**RE: GRADING & DRAINAGE PLAN FOR INS PARKING LOT (M-15/D34)
RECEIVED AUG 16, 1999 FOR PAVING PERMIT
ENGINEER'S STAMP DATED 8-13-99**

I.N.S. BUILDING - RANDOLPH ROAD

GRADING PLAN & DRAINAGE PLAN

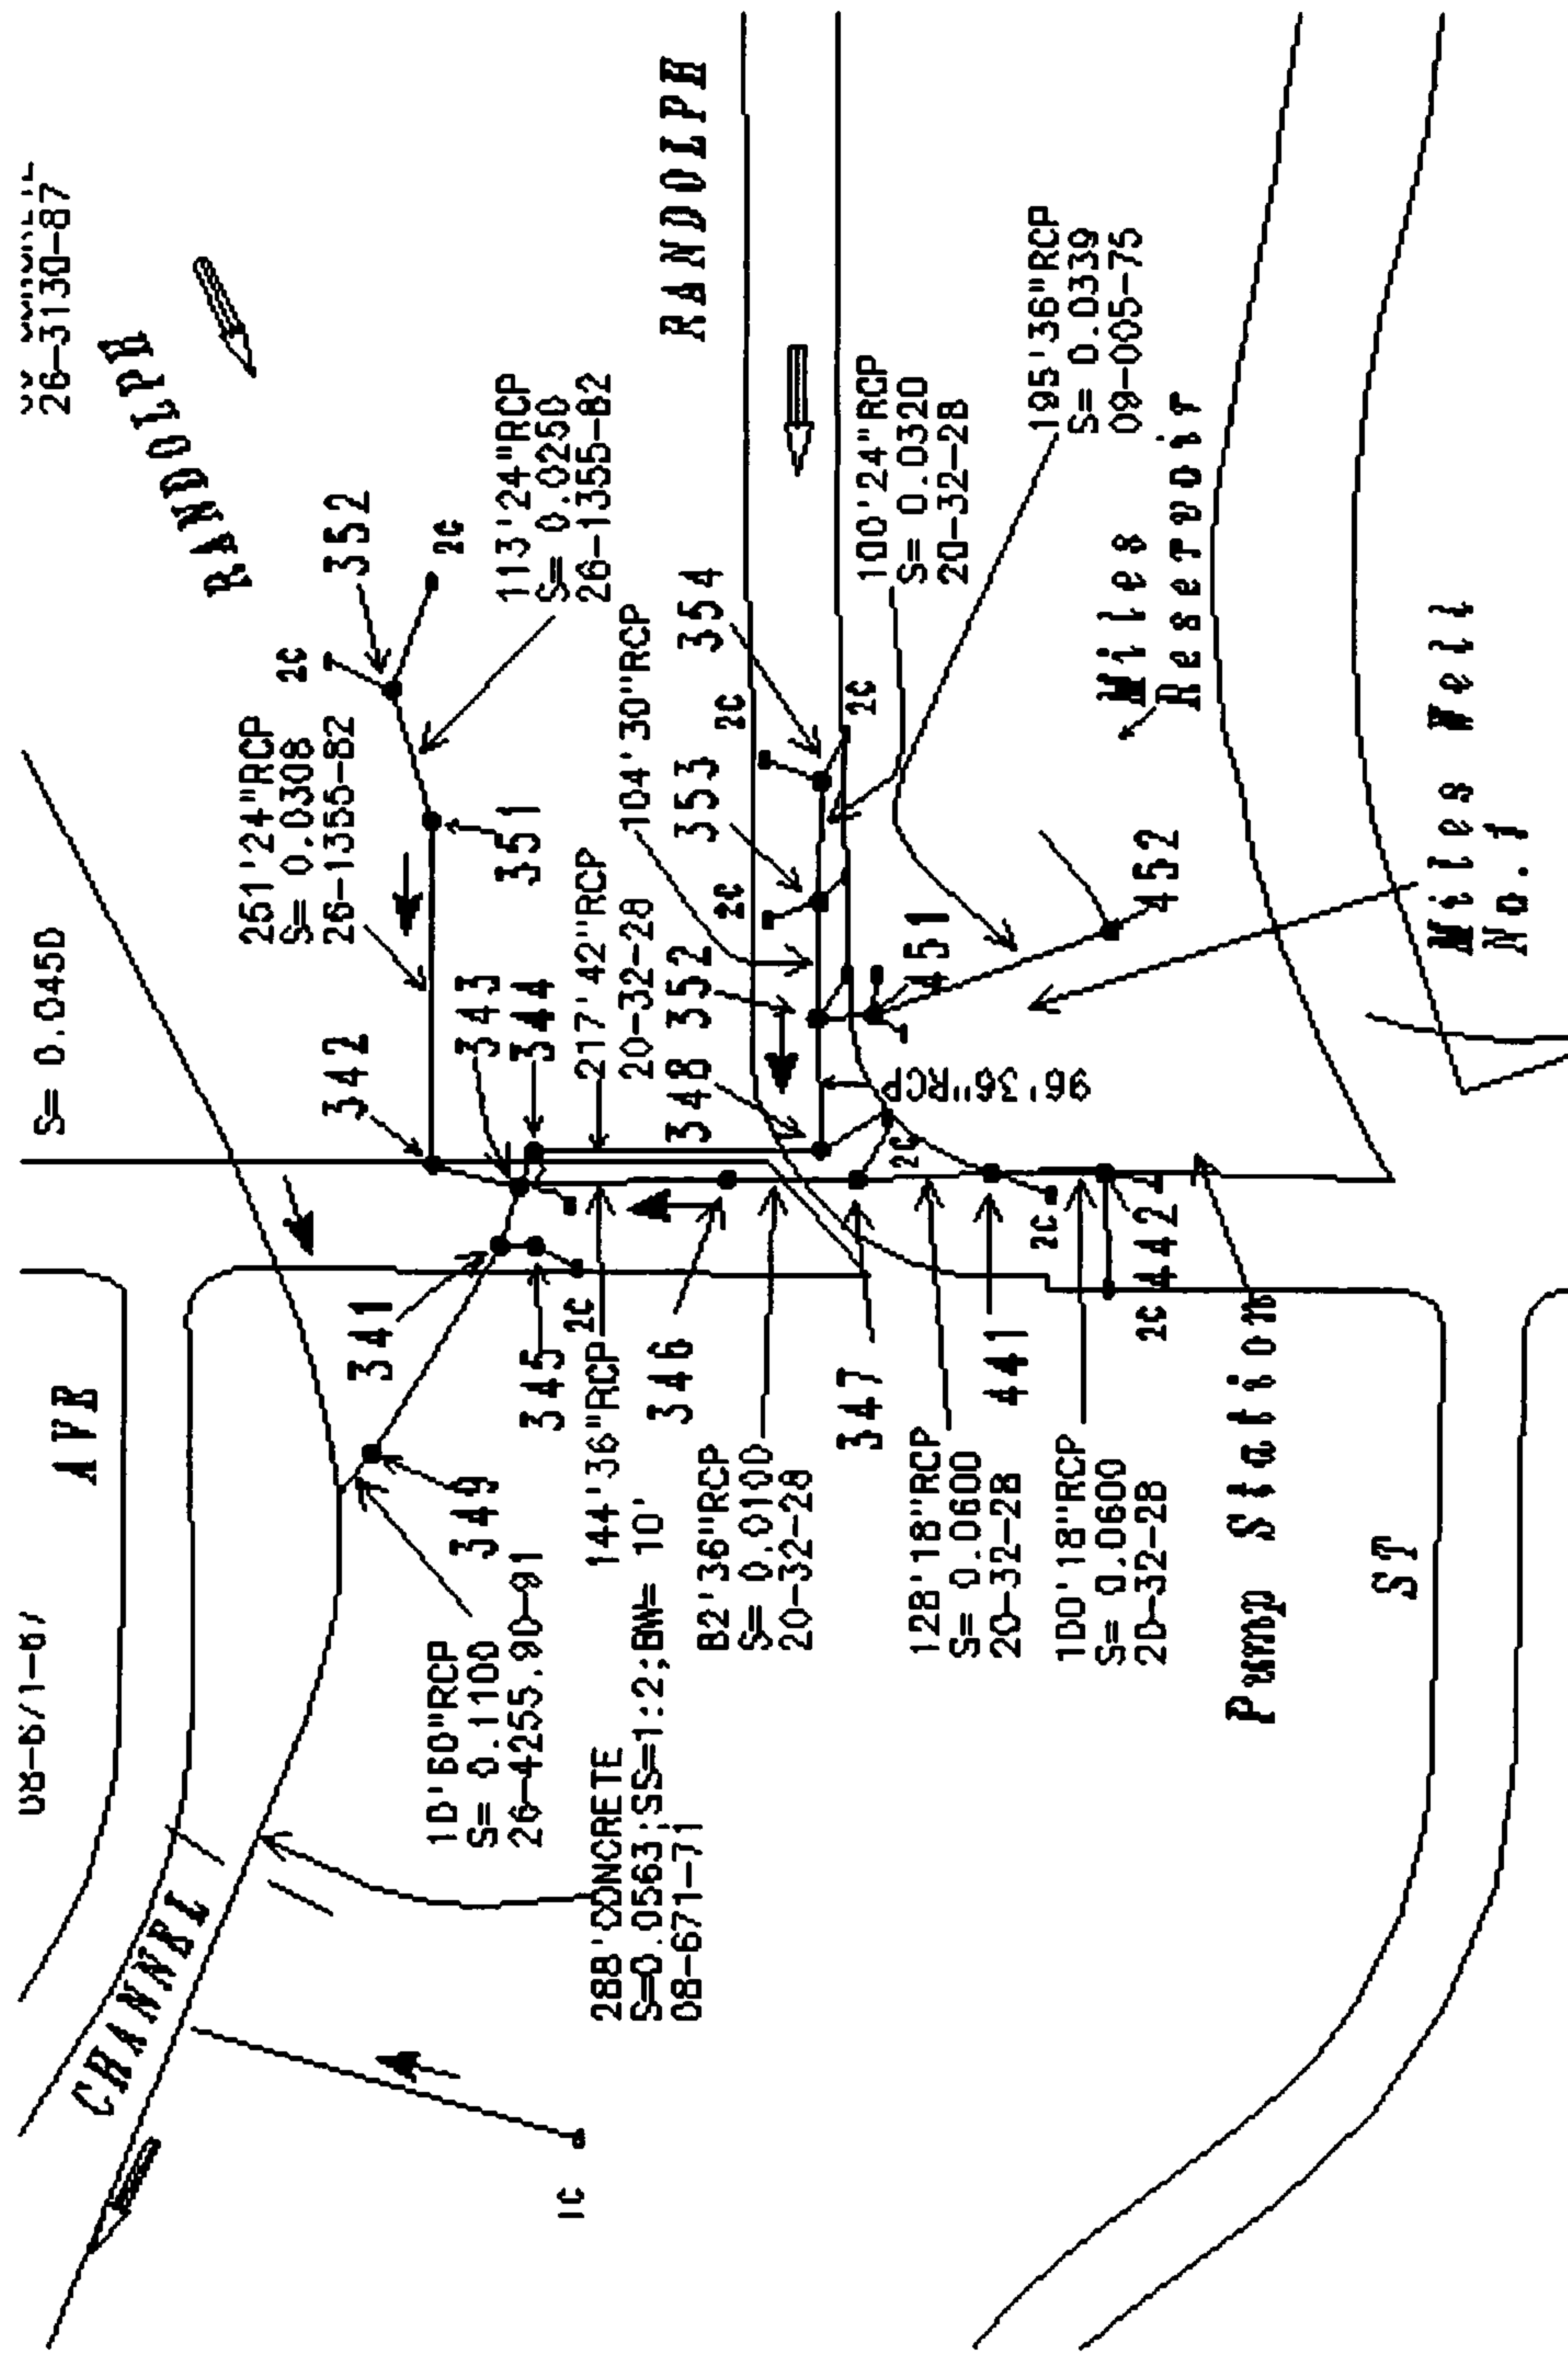
Based on the information included in the submittal referenced above, City Hydrology accepts the grading & drainage plan for paving permit. Ultimately the discharge from the railroad spur will be controlled by the capacity of the storm drain system in University Blvd.

Engineer's Certification of grading & drainage, per DPM checklist, must be submitted to City Hydrology when the paving is completed.
